APPENDIX A - CORRESPONDENCE

**RE: West of Hudson Hydroelectric Project (FERC #13287)
Review of Study Plans**

RE: DECID# 0-9999-00143
West of Hudson Hydro Project
Fisheries Study Plans

Re: DEP West of Hudson Hydroelectric Project (FERC Project No. 13287)
Fisheries Study Plans

Attachment 1: Cross Section of Neversink Intake Structure

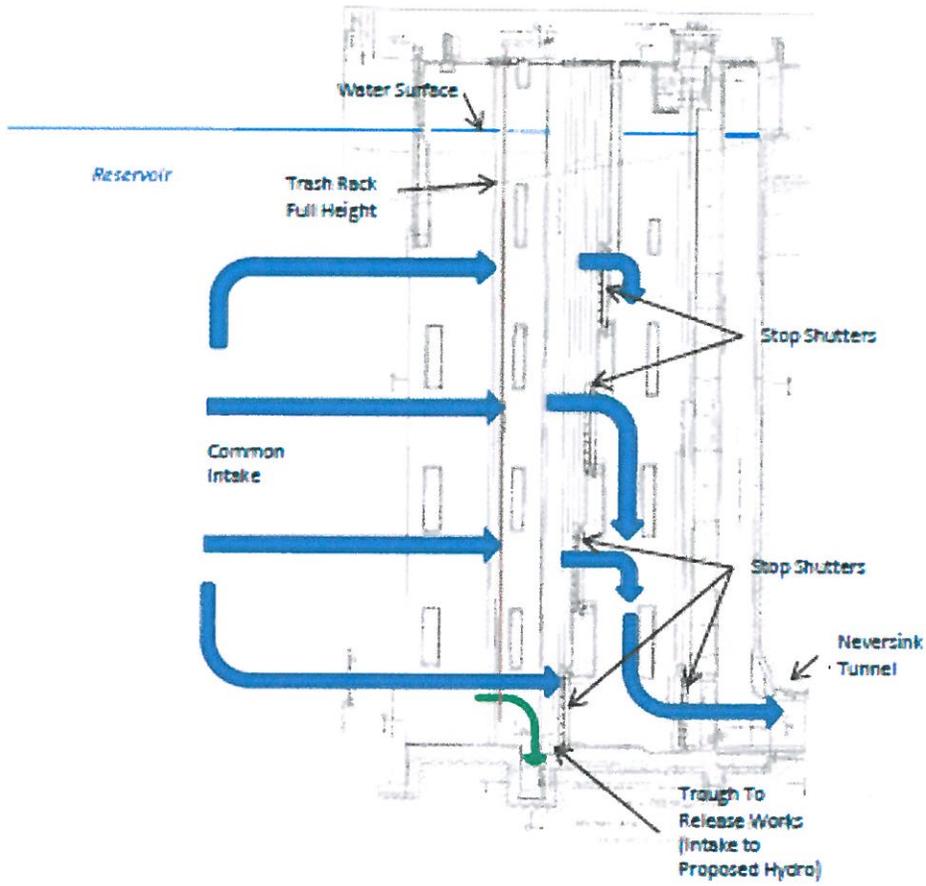
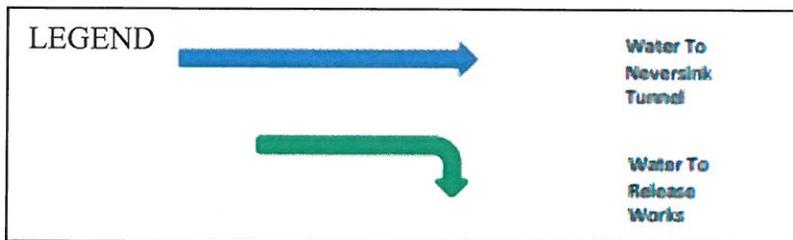
As indicated in the reports submitted by NYC DEP, the intake configuration at the Neversink dam is somewhat unique. The intake is a vertical tower equipped with eight ports. The literature review dated September 2010, does not adequately address a facility with this intake design.

The NYSDEC letter states, “As indicated in the reports submitted by DEP, the intake configuration at the Neversink dam is somewhat unique. The intake is a vertical tower equipped with eight ports. The literature review dated September 2010, does not adequately address a facility with this intake design.”

Although the common intake is a vertical tower with eight segments that span the length of the water column, the intake that conveys water from the forebay to the stream release is at a fixed location at the bottom of the water column (see Attachment 1). It is from this point that water will be conveyed to the proposed hydroelectric turbine. DEP believes that because: (a) the intake to the proposed hydroelectric development is in deep water with an acclimation depth under full pond equal to 151 feet; (b) the intake velocities are very low under all conditions; and (c) acclimation depths consistent with even the less limiting protective criteria associated with physostomous species occurs less than 3% of the time in the Neversink Reservoir fish entrained in the stream release would suffer high mortality rates due to pressure differentials. However, regardless of this expectation DEP believes based on the configuration outside and within the Neversink intake structure the likelihood of entrainment to the stream release is low.

The Addendum (see page 11) clarified a statement made in the Entrainment Report that misrepresented the entrainment potential of fish entering the common intake. DEP revised this statement to indicate that the design of the intake structure is such that all occurrences of potential fish entrainment to the proposed hydroelectric development at Neversink Reservoir would occur at the horizontal troughs on the floor of the intake structure and not from fish entering the common intake in the upper portions of the water column (see Attachment 1).
